## SITE AUDIT REPORT AND SITE AUDIT STATEMENTS

### Caddens Release Area, Kingswood, NSW, 2747

**Report Number:** 097623019 007 R Rev0

**Figure 12** Groundwater Flow

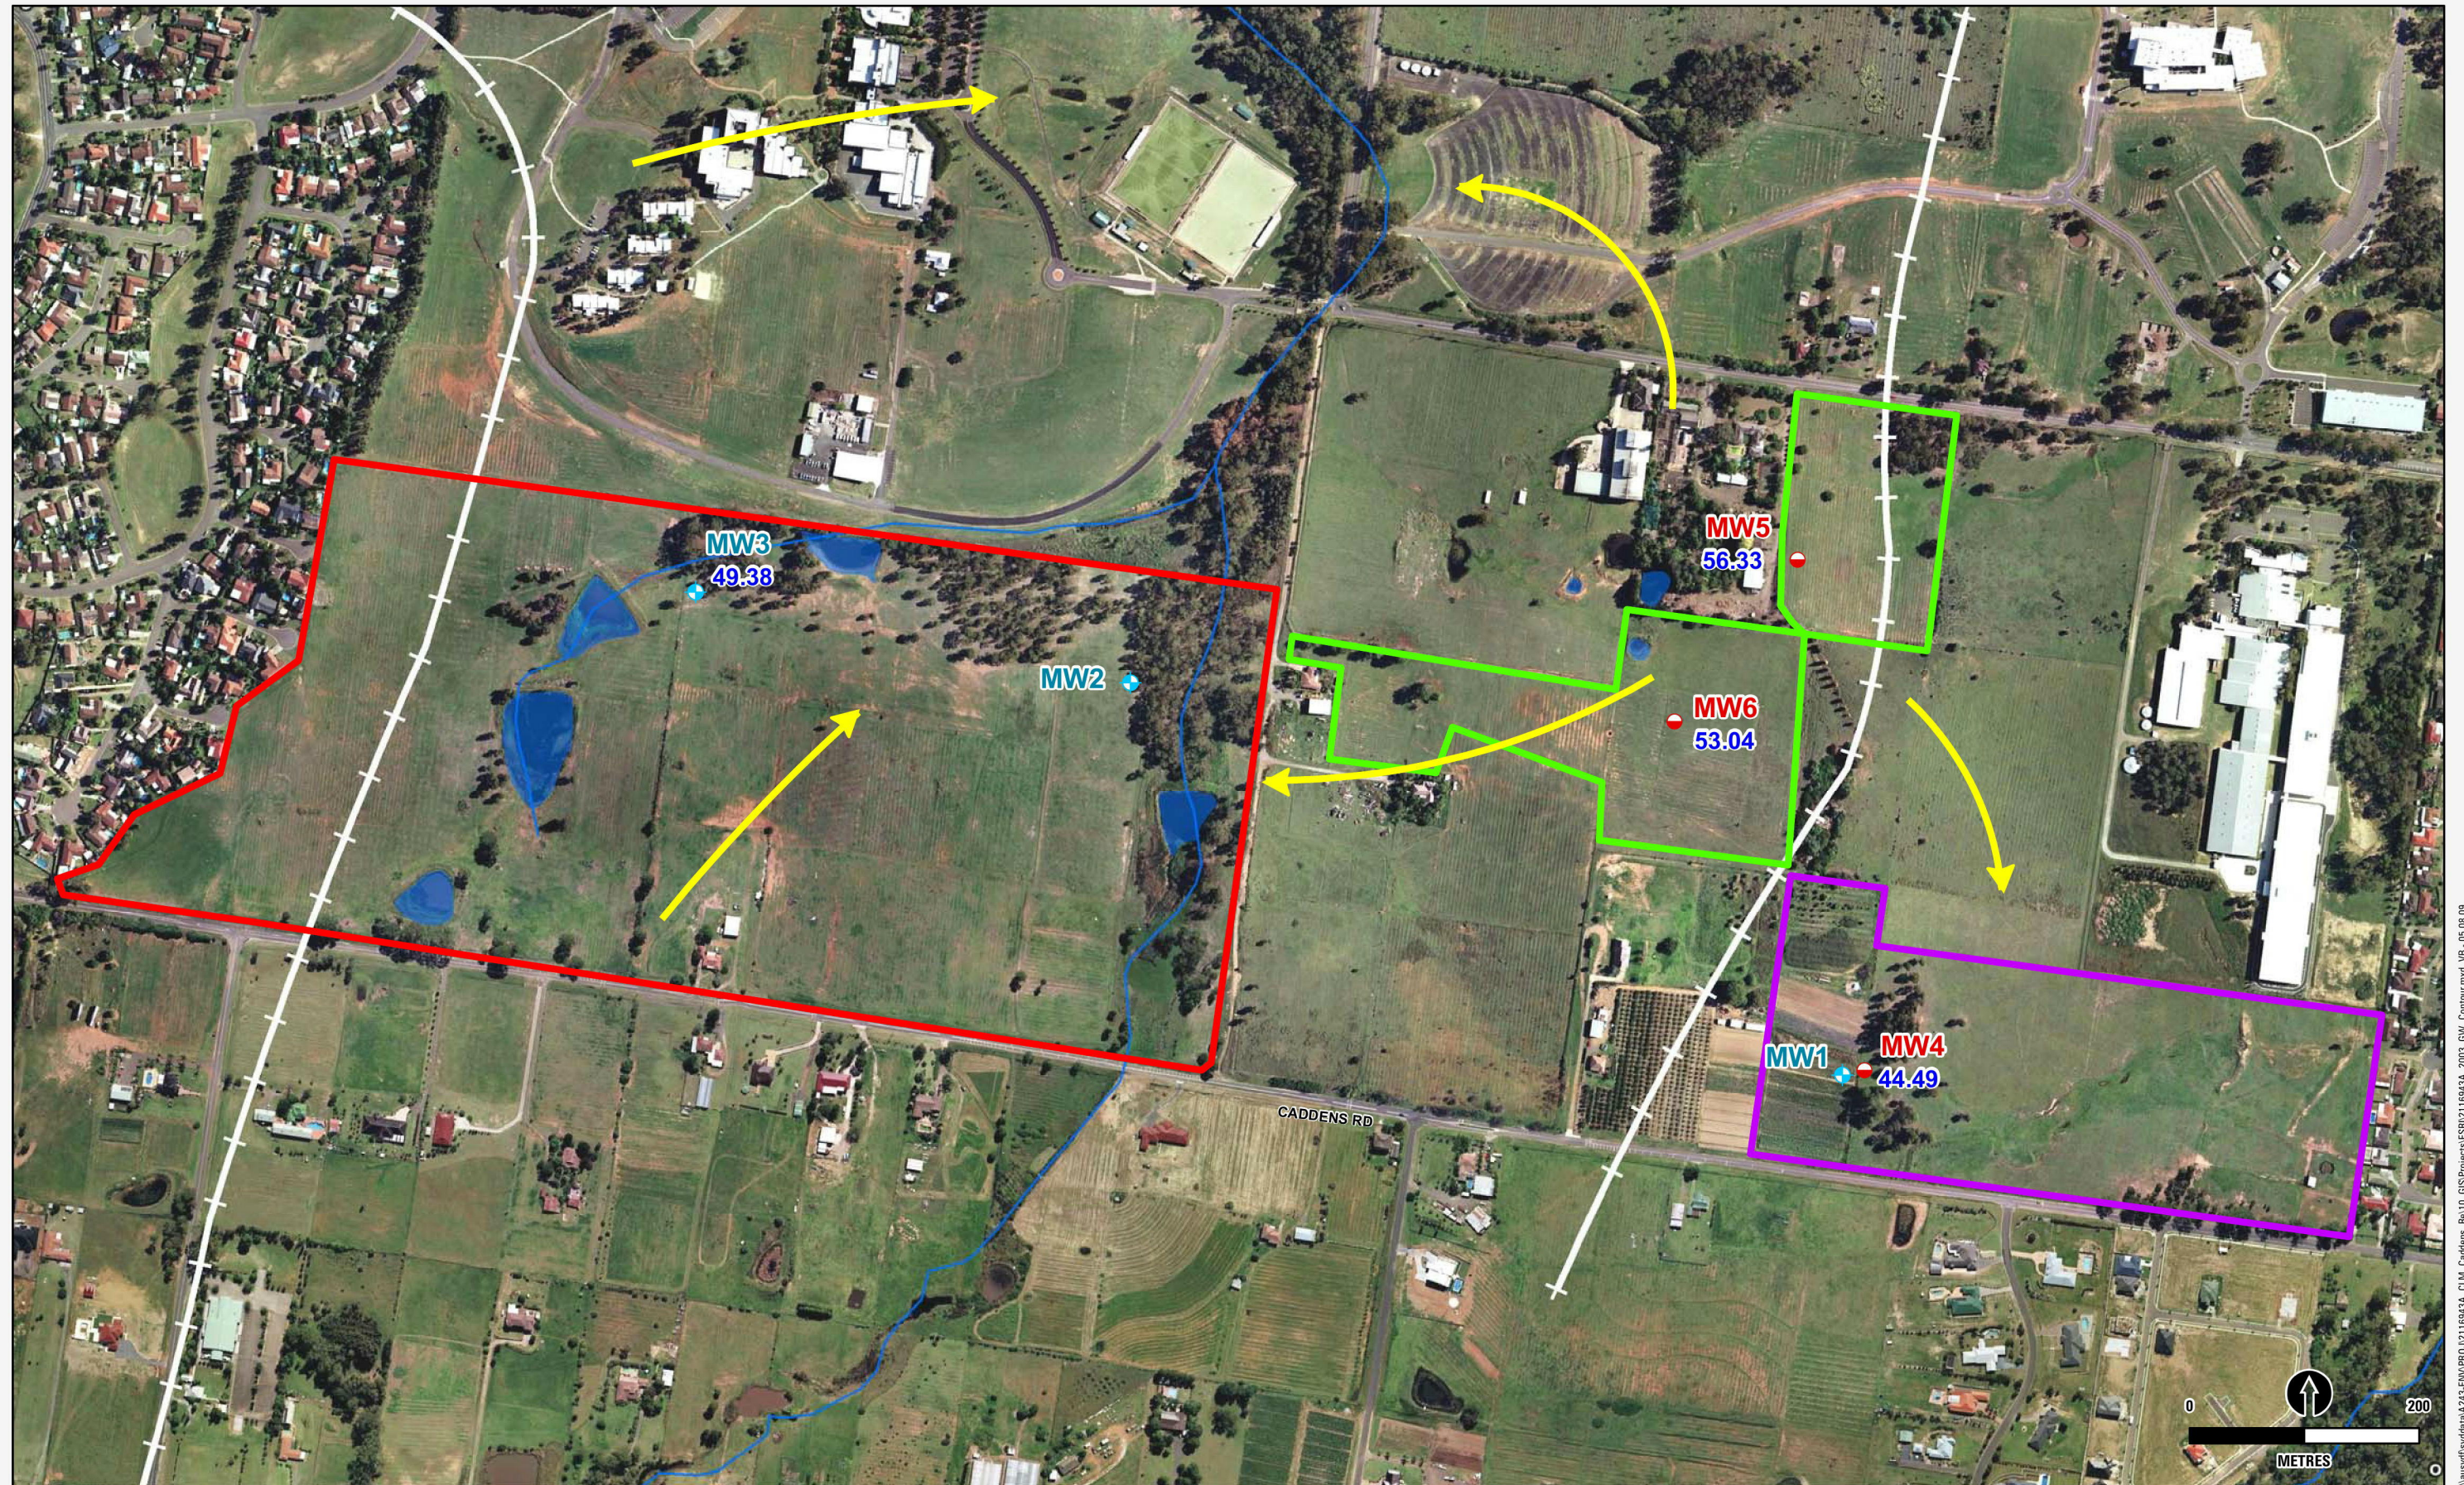
Table 8-4 references Figure 12 which presents interpreted groundwater contours which are plotted to flow in a southerly direction radiating from well MW5. This interpretation contradicts the direction of flow inferred from published information (Section 3.4), and the direction of flow of the creek that bisects the Site.”

The Site is bisected by Werrington Creek that flows to the north. Monitoring wells MW4-MW6 and MW3 are located on the western side eastern side of the creek respectively. The interpretation of groundwater flow on Figure 12 (PB, 2009b) was undertaken incorrectly by contouring the elevation of the watertable and ignoring the influence of the drainage lines. It is assessed there is insufficient data to contour the groundwater elevation to produce a potentiometric head contour map.

Reference to the topographic map indicates the Site is intersected by catchment boundaries to the east and west as shown on Figure 12. The watertable elevation in an unconfined aquifer is typically a subdued reflection of the topographic surface. Groundwater flow is inferred to be perpendicular to the catchment boundary and towards the creek systems. Thus groundwater flow at the eastern part of the Site is radial from MW5 (centred on a local topographic high) and elsewhere generally northward flowing in the direction of Werrington Creek. Analysis of groundwater levels from monitoring wells MW4, MW5 and MW6 confirm local groundwater flow (in the south eastern part of the Site) is in a south-westerly direction towards Werrington Creek.
